## REVIEWER #1

### Synopsis:

In this paper, the first airborne microwave wide-band radiometer observation over Antarctica is explained. It is very well written with great results of the of the campaign. I believe this manuscript is applicable for publication in this journal after addressing few comments (some editorial).

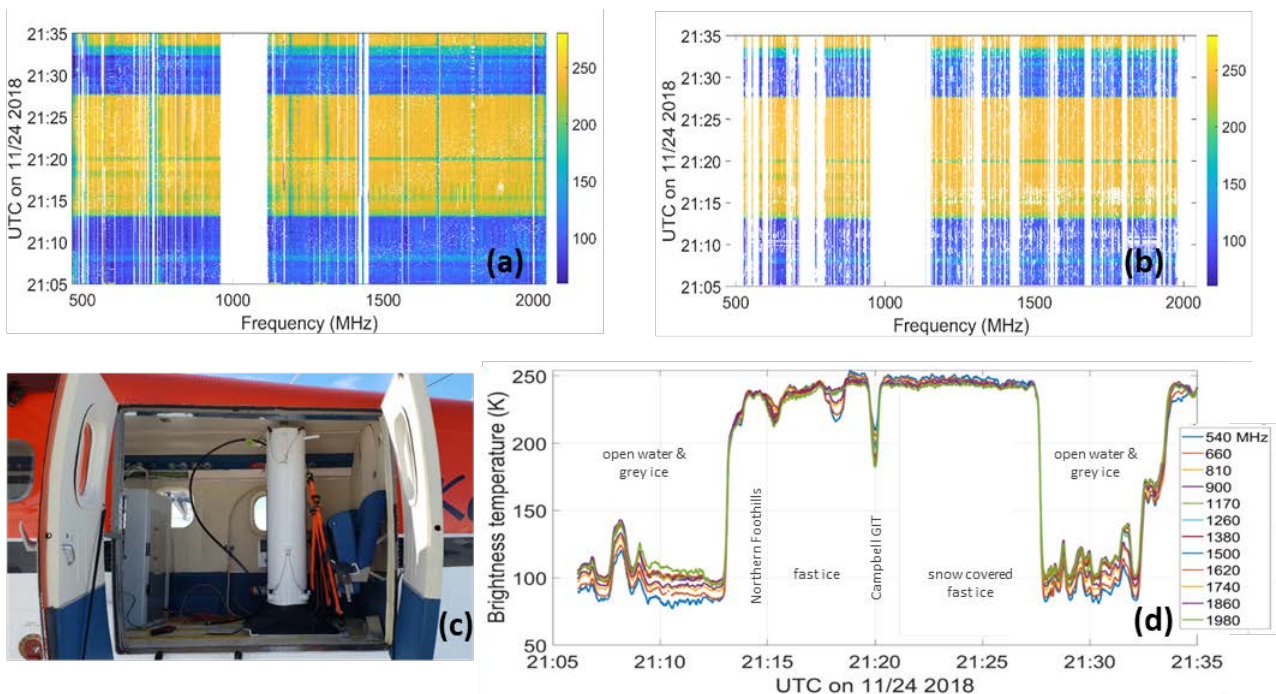
1. The two top figures in Fig. 1 are very close to each other and misleading for readers' eyes. Can you please separate them somehow? Perhaps tag the figures as a, b, c, d. Or add colorbar to the left figure, or make the box around the figure to be bolder and more distinguishable.

4. Regarding my third comment, lower right figure in Fig .1, why lower frequency of 540 MHz is the coldest before about 21:13 UTC, then it becomes hottest after that? This is opposite of the claim you had for lower frequency. Can you please explain this?

Thanks for the suggestion. The figure has been improved resulting in a higher clarity. It is reported hereinafter for your convenience.

The previous statement refers to inland ice sheets while Fig.1 illustrates, as an example, the spectral behavior over different components of the cryosphere. Over open water, all channels are cool with the lowest channels coldest because of the dielectric behavior of the water. Over thinner sea ice (as at 21:13), the low frequency are more sensitive to the radiometrically cold ocean water underlying the ice. Over the thick, low-loss glacier ice of the Campbell Glacier, the low frequencies are more sensitive to the warming thermal gradient in the ice. The figure was intended to provide the reader an idea of how the timeseries collected by UWBRAD looked when it observed different natural targets. In particular, the data before 21:13 UTC refers to open water and grey ice, which explains the low Tb values. Soon after moraine and fast ice are observed with completely different spectral features. Comment 3 refers to the inner ice sheet which was not covered in figure 1.

Thanks to your comments we recognize that figure can be improved in order to help the reader understand the general behavior of Tb. We have annotated Fig. 1 as

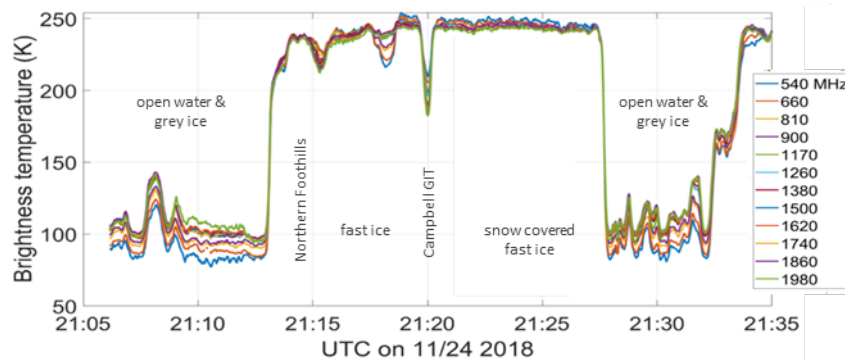
## 3. Regarding the claim in line 5 (in the abstract) where it is mentioned that lower frequency shows warmer since it senses deeper into the ice where it is physically warmer, I think this statement is not necessarily true, and any boundary with a huge dielectric constant difference at deeper layers can drastically drop the L-band or lower frequency TB. Can you mention this point more cautiously, or explain it further?

The sentence is only intended to provide the reader with a rule-of-thumb for interpreting the data we will show. It is true that any strong dielectric discontinuity affects the electromagnetic emission and deviates by the general behavior described for inland ice (in particular on the East Antarctic Plateau). This is exactly what we notice over the Nansen ice shelf, where the subsurface structures created in the firm by the seasonal melt/refreeze "mask" the emission from the ice below. Also, it is the basis for subsurface aquifers monitoring, a topic we are working on especially for Greenland and at which we hint in section 5.5 while describing the data over Enigma Lake.

The sentence “Generally, the brightness temperatures over the inland ice sheet were warmest at the lowest frequencies consistent with models that predict that those channels sensed the deeper, warmer parts of the ice sheet.” has been reworded as:

“Generally, the brightness temperatures over a vertically homogeneous ice sheet are warmest at the lowest frequencies consistent with models that predict that those channels sensed the deeper, warmer parts of the ice sheet. Vertical heterogeneities in the ice property profiles can alter this basic interpretation of the signal.”

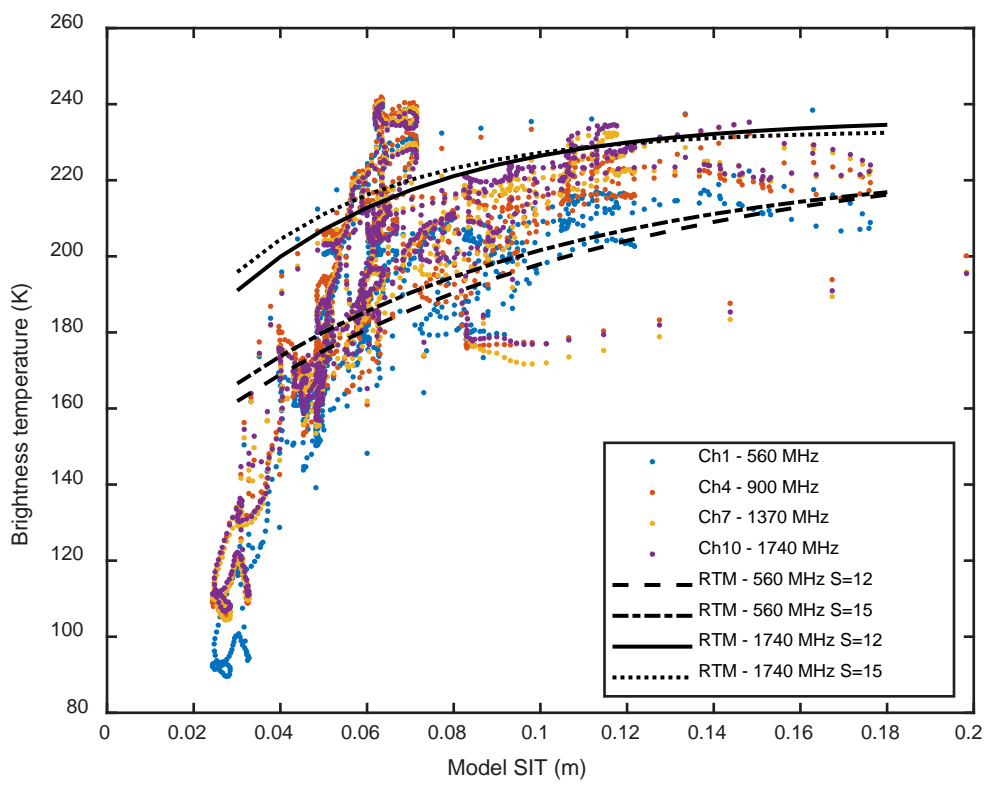
6. Please explain for the reader that why the RTM model in bottom right figure did not go less than about 4cm.

We choose to show the RTM simulations starting from 5 cm because RTM is a widely used incoherent model that assumes a single homogeneous planar slab of sea ice above water. The model breaks down when the overlying layer becomes thinner than a few cm of sea ice. More specifically, a layer thinner than a quarter of the wavelength (15 cm at 0.5 GHz and 3.5 cm at 2 GHz) cannot be treated with conventional/simple wave propagation approach and a coherent RT should

be used. As described in the text (line 297) the analysis was intended to show the potential sensitivity of UWB radiometry to SIT even for high saline shallow ice and corroborate it with electromagnetic model simulations. At line 300 we added the following sentence in order to clarify such limitation:

“RTM simulations assume a finite thickness slab of sea ice over water, and the calculation starts from a minimum thickness of 5 cm since for lower values the incoherent model fails to simulate correctly the e.m. emission. Actually, layers thinner than a quarter of the wavelength (about 15 cm at 0.5 GHz and 3.5 cm at 2 GHz) cannot be treated with conventional/simple wave propagation approach and a coherent RT should be used (which requires a highly accurate characterization of the medium surfaces seldom available in such scenarios).”

Hereinafter we report the same plots with RTM simulations starting at 3 cm but we believe that it doesn't add too much information to the paper.
